SKAGIT RIVER HYDROLOGY INDEPENDENT TECHNICAL REVIEW FINAL REPORT

Prepared for: Skagit County Department of
Public Works

Prepared by: Northwest Hydraulic Consultants

Appendix:	Comments on February 2007 Draft Report with Responses.....	39
-----------	--	----

Figure 3

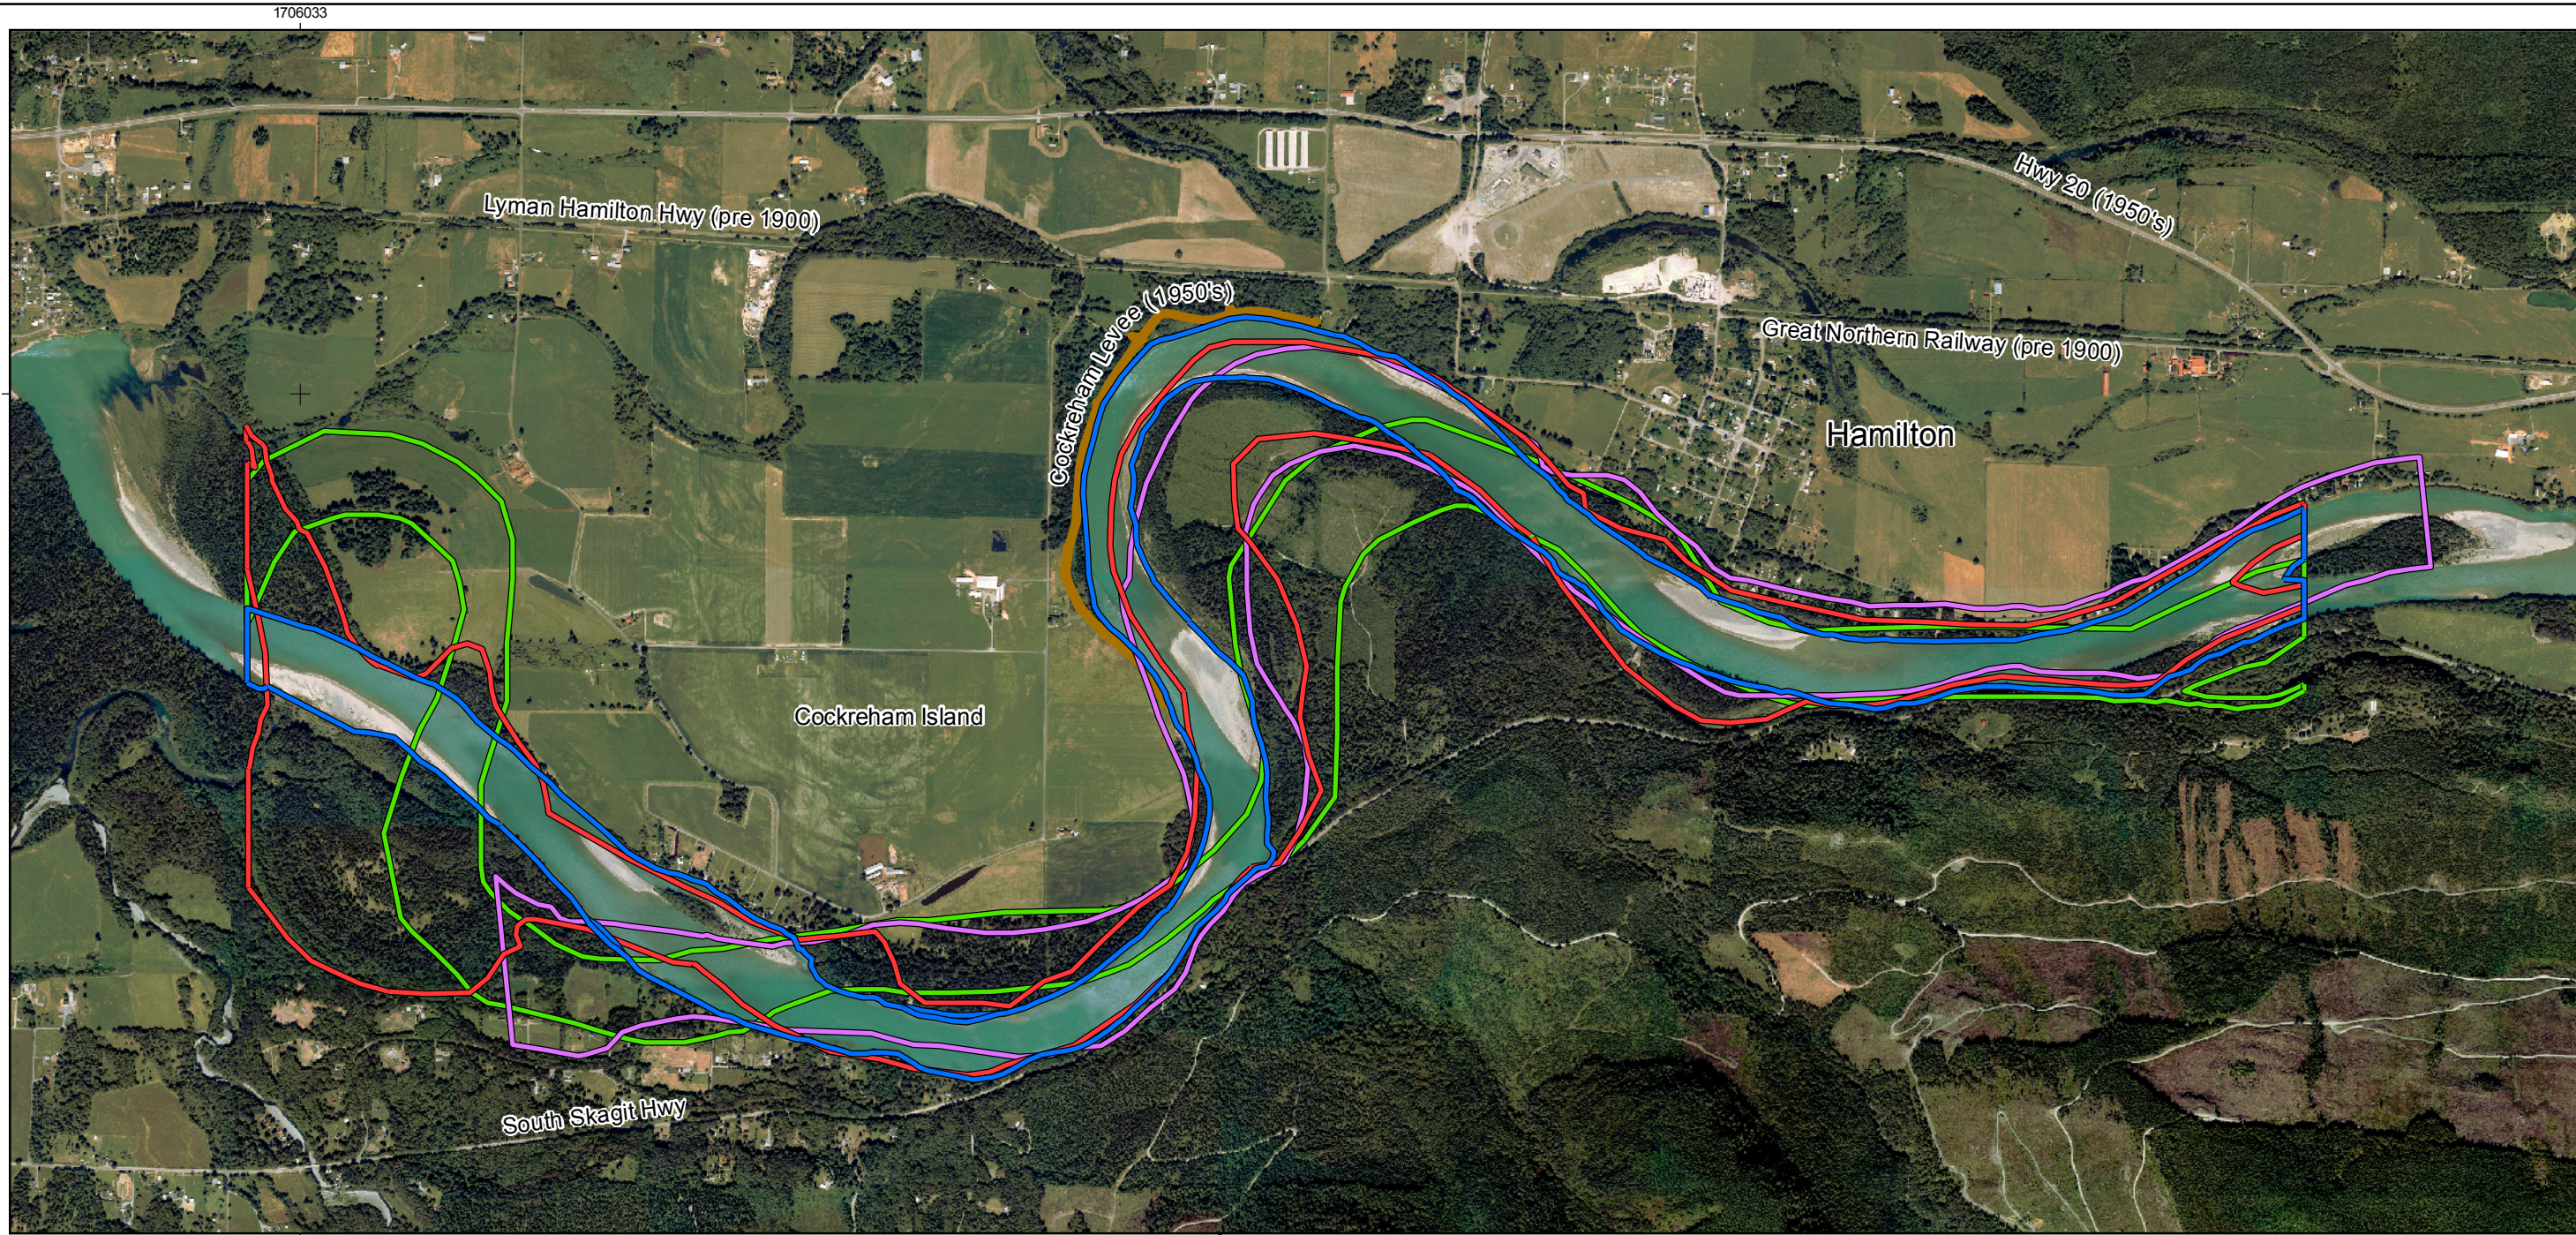
5. page 8: I will attach the pdf file of the COE 1911 map of the Hamilton reach. Maybe that could be incorporated into the migration map on figure 3. **The 1911 banklines have been added to Figure 3 and the text modified. The 1911 bank lines are similar to or wider than those of 1937 and if anything reinforce our conclusions that the river could have carried appreciably more water at the time of the historic floods.**

NHC RESPONSE: Bank lines from the COE map of 1911 will be added to Figure 3 of our report and text will be modified accordingly. The 1911 bank lines are similar to or wider than those of 1937 and our opinion remains that because of channel changes between 1886 and present, it is not possible to demonstrate that the Smith House would (or would not) have flooded at a discharge of 240,000 cfs in 1921. Fundamentally, information is not available to the necessary standard to reach a definitive conclusion on this issue. Prompted by a comment from Chal Martin we have done some sensitivity runs with the hydraulic model which demonstrate that with the magnitude of channel changes from past to present, it is quite possible that the river could have carried 240,000 cfs or more in 1921 without flooding the Smith House. The text will be modified to make reference to the sensitivity runs.
